TOWN OF HAYMARKET PLANNING COMMISSION

CONTINUATION MEETING ~ AGENDA ~

1. Crossroads Village Center

VIRGINIA DEPARTMENT OF TRANSPORTATION PRINCE WILLIAM LAND USE PROJECT REVIEW COMMENT AND RESOLUTION SHEET				TIA - NOT ACCEPTED (SEE COMMENTS)		COMMENT CATEGORIES: 1. REQUIREMENT 2. RECOMMENDATION	
COUNTY NUMBER: HAYMARKET REZ 2014-1029			DEVELOPER/ENGINEER: GOROVE/SLADE		REVIEWER(S): HIREN C JOSHI; P.E. /MOHSIN ZAIDI, P.E.		DATE: 06/05/18
PROJECT NAME: CROSSROADS VILLAGE CENTER			REVIEW PHASE & TYPE: 2ND REVIEW TIA		DISCIPLINE: PWC LAND USE & TE SECTION

DES: SEM	DWN: GMG	CHK: RMM
FILE NO. DP #511		
SHEET 1 OF 1

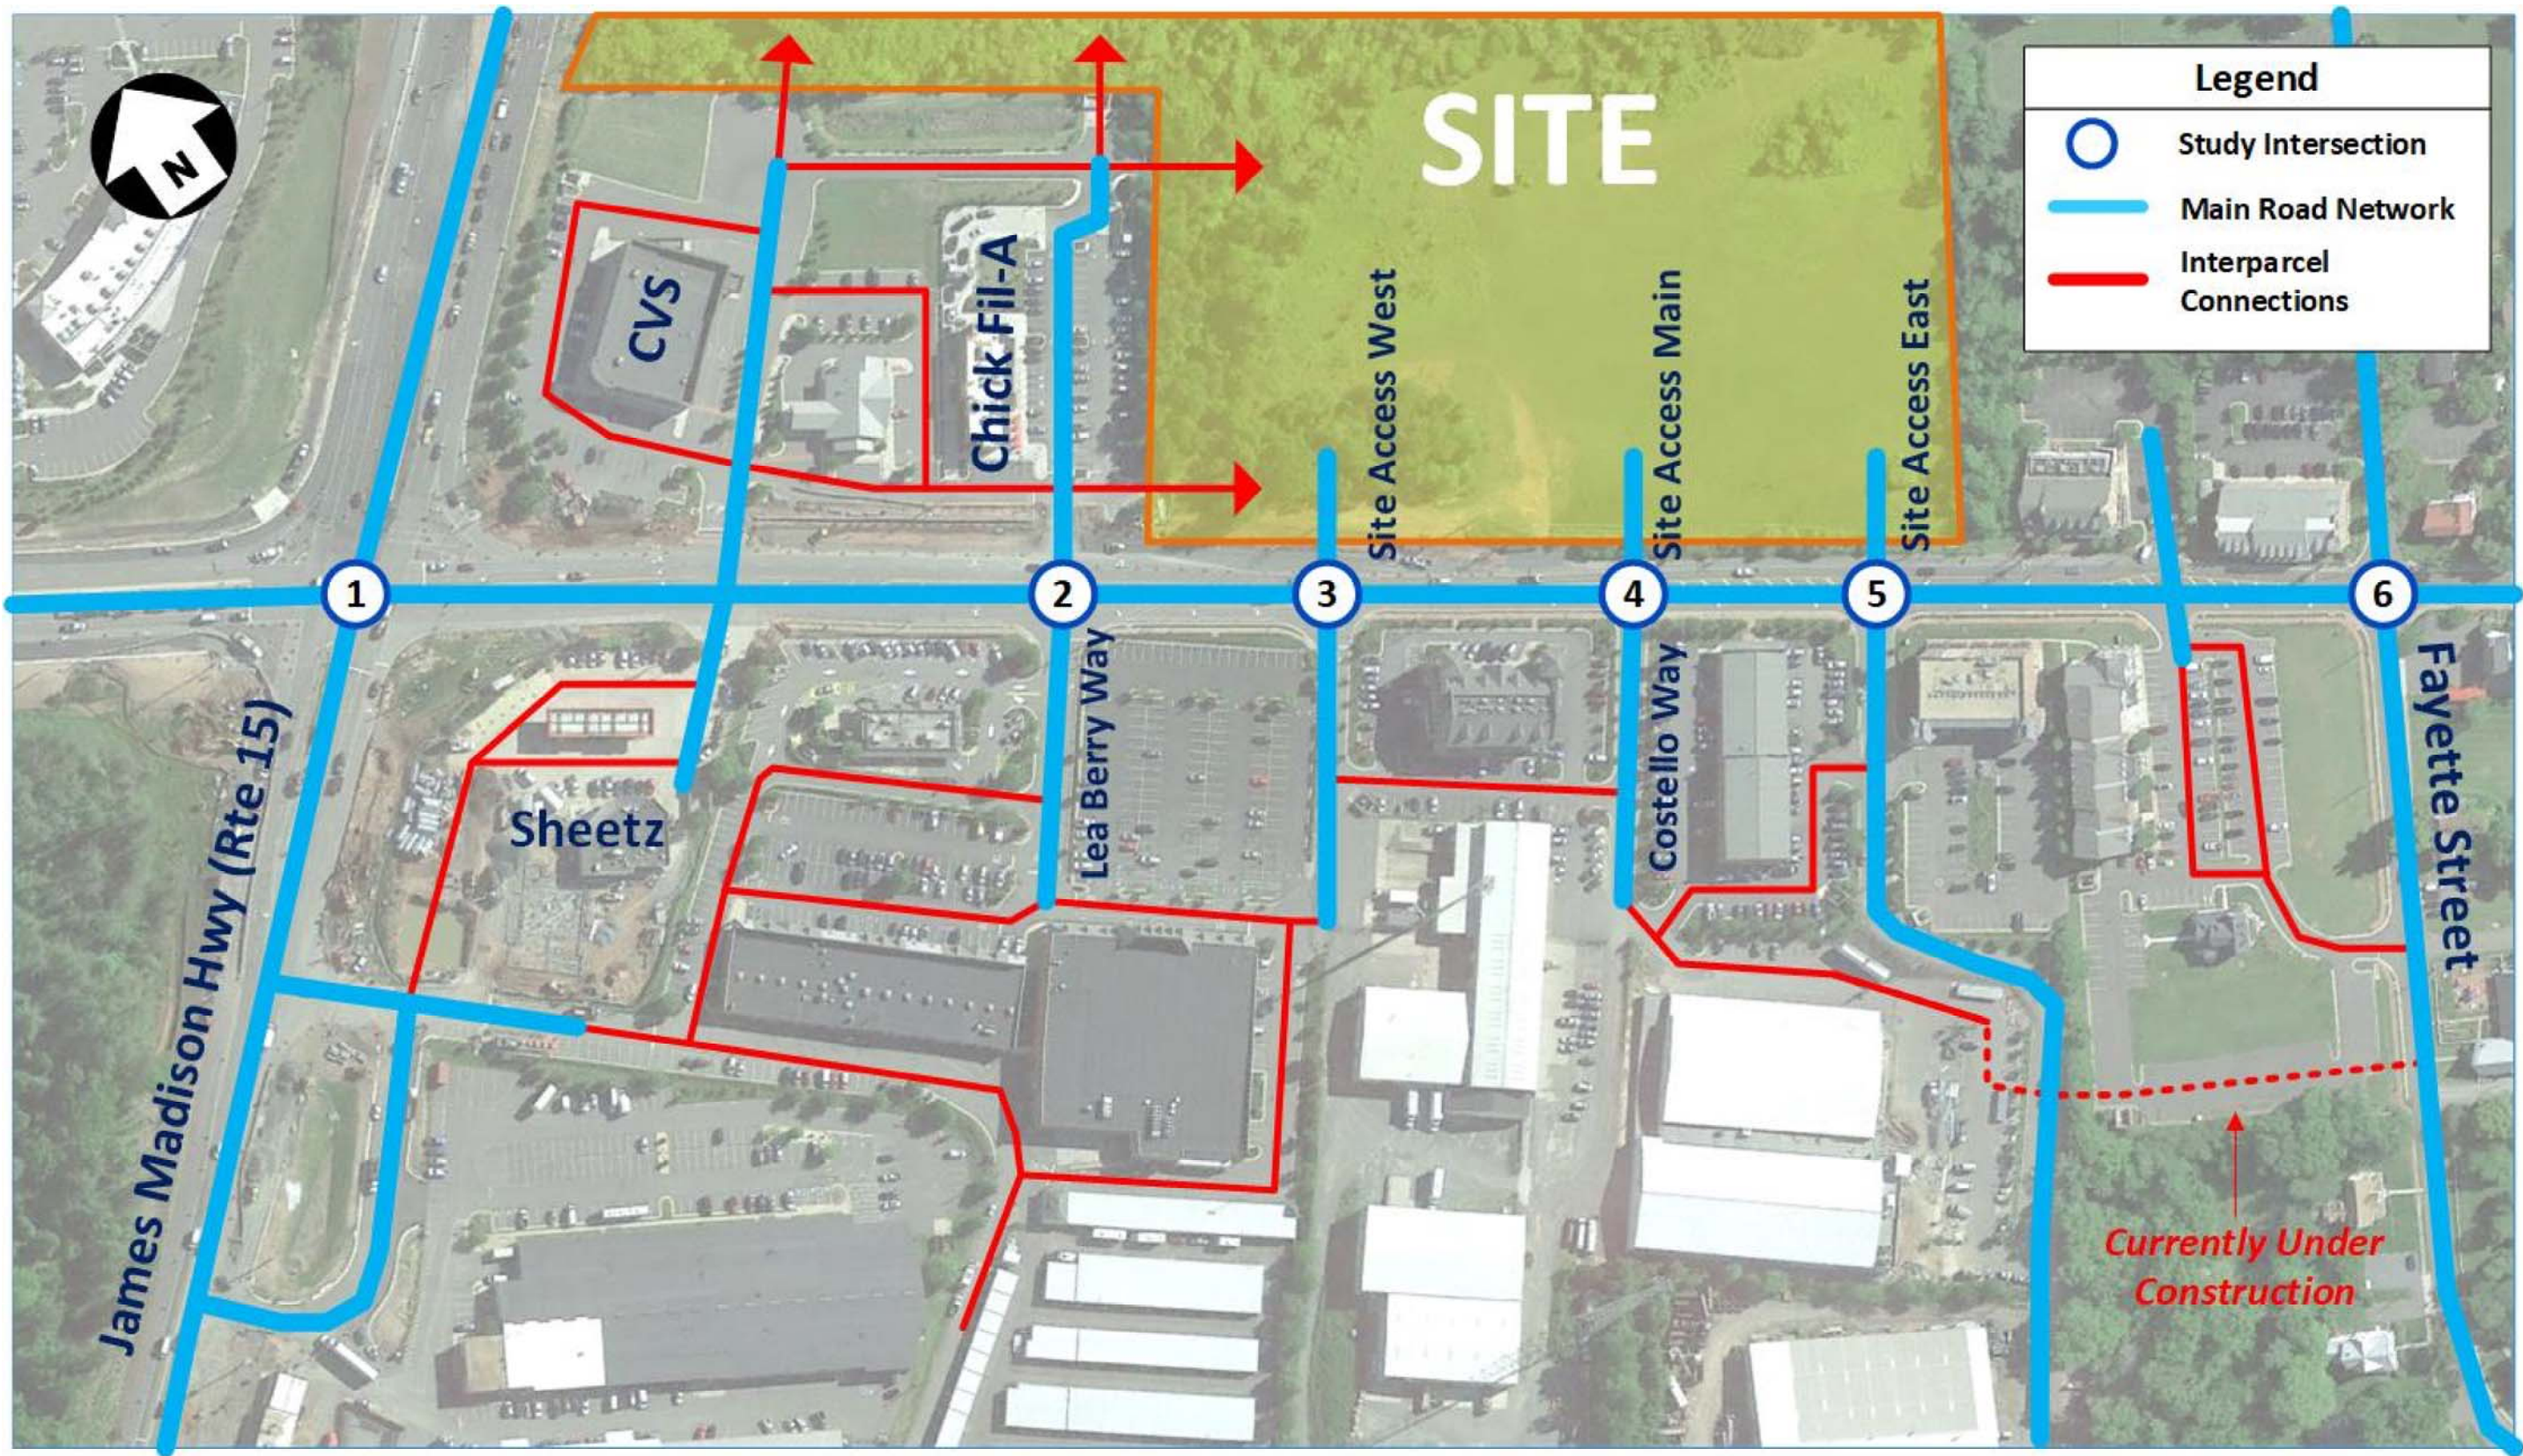
DATE	BY	REVISION
5/31/18	RMM	REVISED PER TOWN COMMENTS
